CITY OF ALBUQUERQUE

RE: Lot 11 Block 1 Unit 5
6709 Rim Rock Cir. NW
Grading and Drainage Plan
Engineers Stamp Date 7/28/2021 (D10D21)
Pad Certification Date 12/10/2021

DRAINAGE PLAN Rio Grande Lingineering PO BOX 93924 ALBUQUERQUE, NM 87199 (505) 321-9099

C1

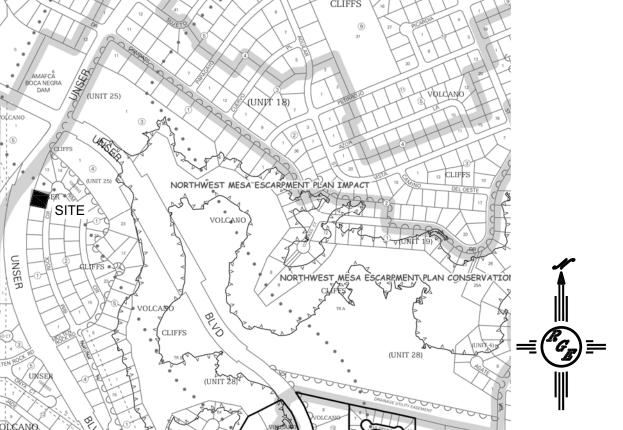
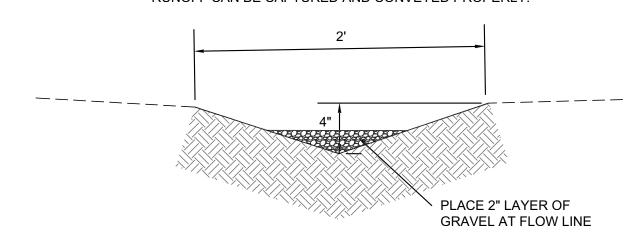
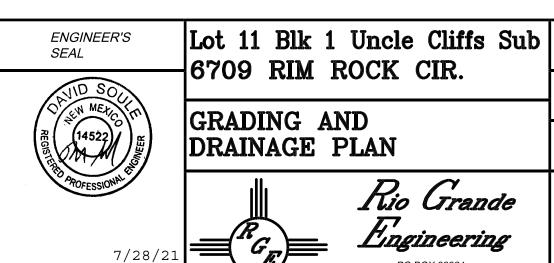
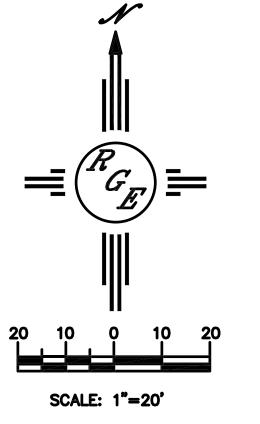
Based upon the information provided in your submittal received 12/10/2021, this plan is approved for Building Permit.

Reiterate to the Owner/Contractor that a separate permit for a garden/retaining wall must be obtained, with the approved G&D plan. Also, advise the owner/contractor not to use dirt as a ramp to climb the curb. If dirt is used it will cause a delay in permitting.

Prior to Certificate of Occupancy release, Engineer Certification per the DPM checklist of this plan will be required.
